INTERNAL MEMORANDUM

To: David Cross
Re: Planning Application P/19/0073
From: Landscape Architect
Ask for: Tom Bramley
Ext: 6276

Provision of 36 camping pods and 5 chalets, erection of shower/toilet block and creation of play and picnic area. Construction of new parking area (141 spaces) with overflow carpark (85 spaces), together with a trail maintenance yard, new highway access routes, ground profile works, drainage,, infrastructure and landscape works at Bike Park Wales Gethin Woodland Centre Abercanaid

Bike Park Wales Proposed Development - 3.5km Radius Visibility Study

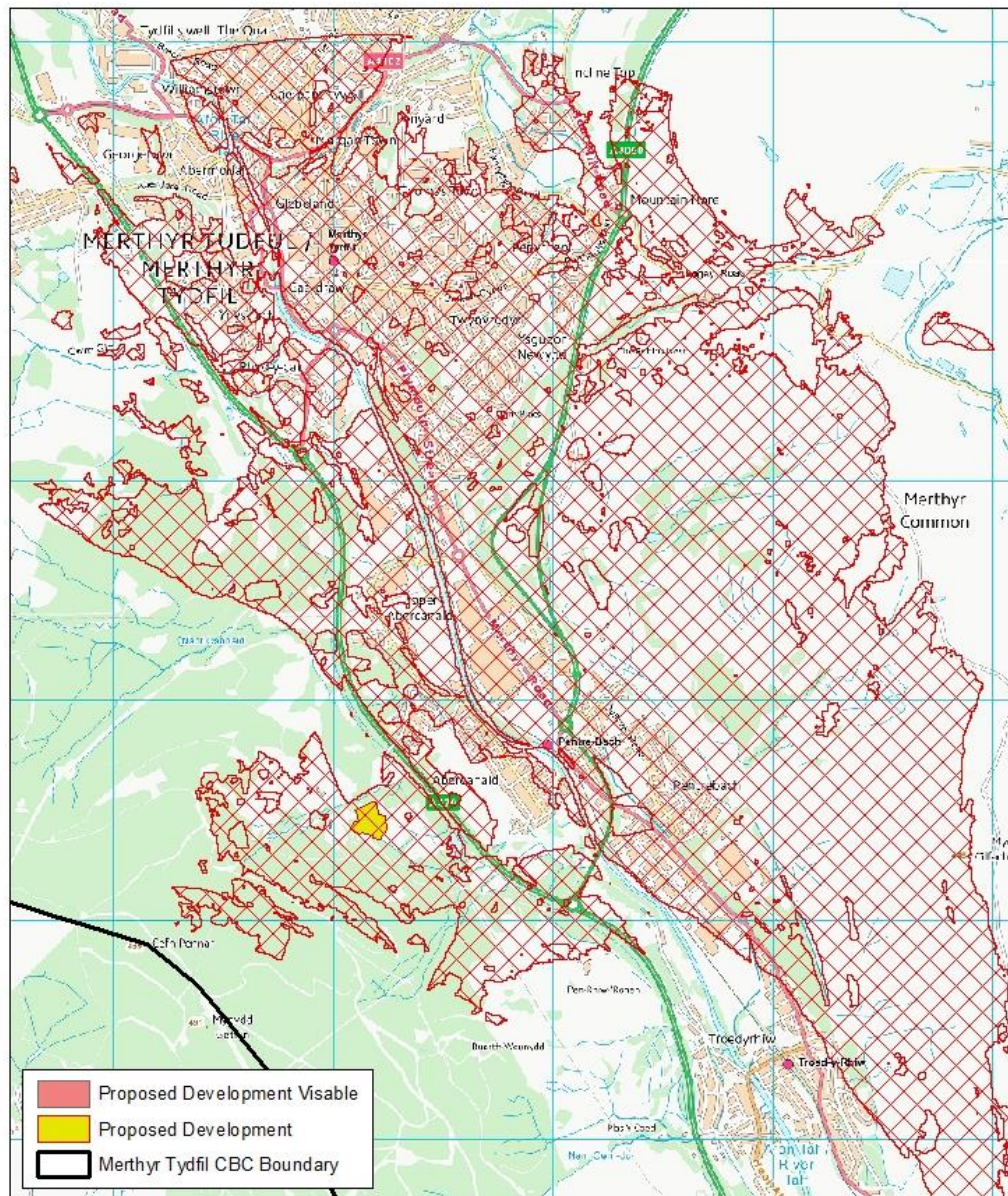
A ZTV has not been prepared as part of the Landscape and Visual Impact Assessment. Our own internal assessment carried out based on an average height of 2.5 metres for all structures proposed (attached), demonstrates a 3.5km radius of potential visibility with the development. Taking a look at the most likely areas of visual capture (location and elevation) the following suggested areas would require a more detailed analysis including a projection of the development within a proposed photomontage:

Whilst it is acknowledged that attempts have been made to describe the likely visual impacts from within the site, there are few montage representations of how the development might appear. Tested inter-visibility from selected viewpoints might have an adverse effect upon those who live, work or move within the landscape and therefore requires closer inspection.
